Manual 14-D Generator Operational Requirements Revision 50

Vince Stefanowicz
Sr. Lead Engineer, Generation
Markets and Reliability Committee
September 26, 2019

M-14D Requirements for Energy Storage Resources

M-14D – Changes Specific to ESR Participation Model - Metering

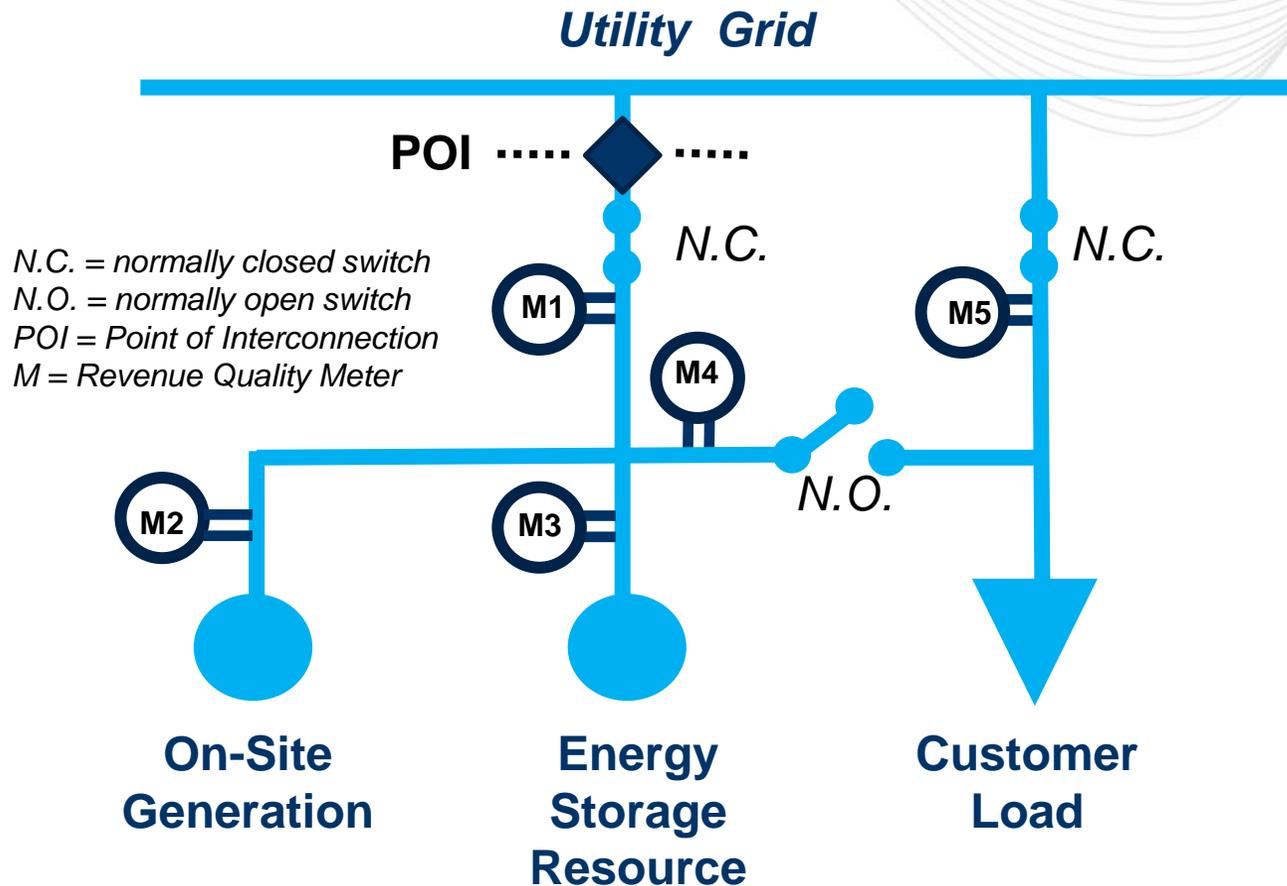
Section 4.2.3: Metering for Individual Generators

- Added metering requirements specific to Energy Storage Resources
- Metering requirements vary based on implementation of ESR

Number and location of measurement devices required will vary depending on how ESR operates

Energy Storage Resources that are co-located with end use load that is not Station Power shall provide a device for measurement of MWh located directly on the Energy Storage Resource terminals (M3 in diagram at left.)

M-14D – Changes Specific to Inverter based ESR

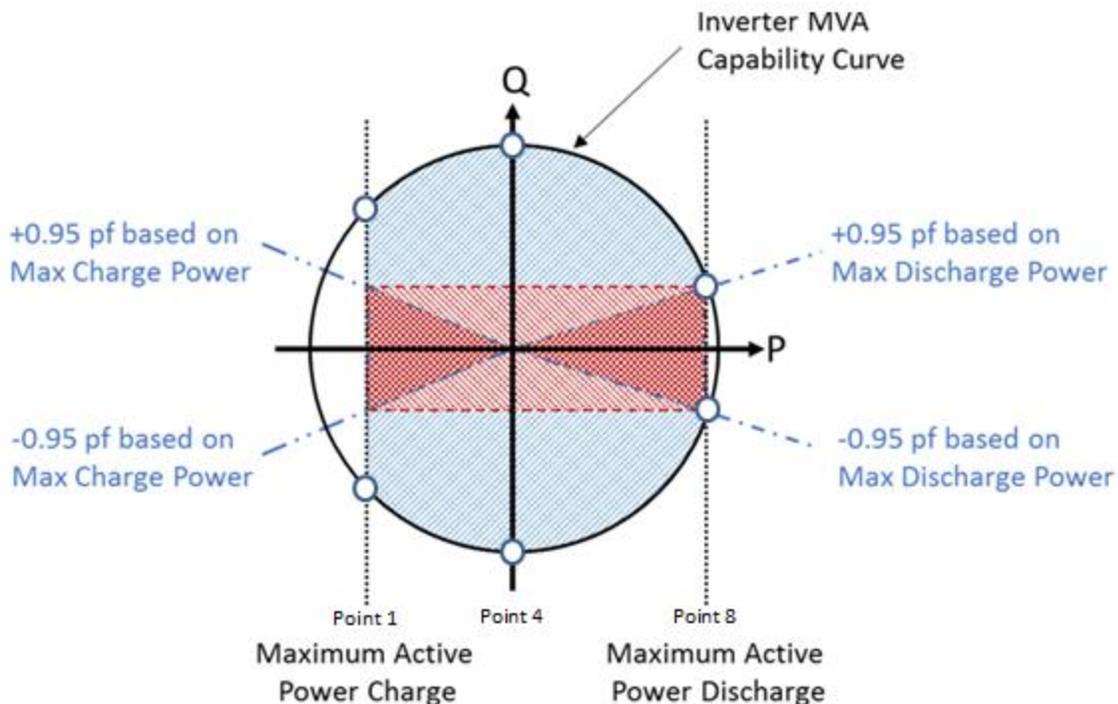
For inverter-based Energy Storage Resources, the reactive capability should be based on Inverter MVA Capability Curve.

Consistent with NERC Guideline on Reactive Capability for Inverter-based Energy Storage Resources

Example of an Inverter-based Energy Storage Resource
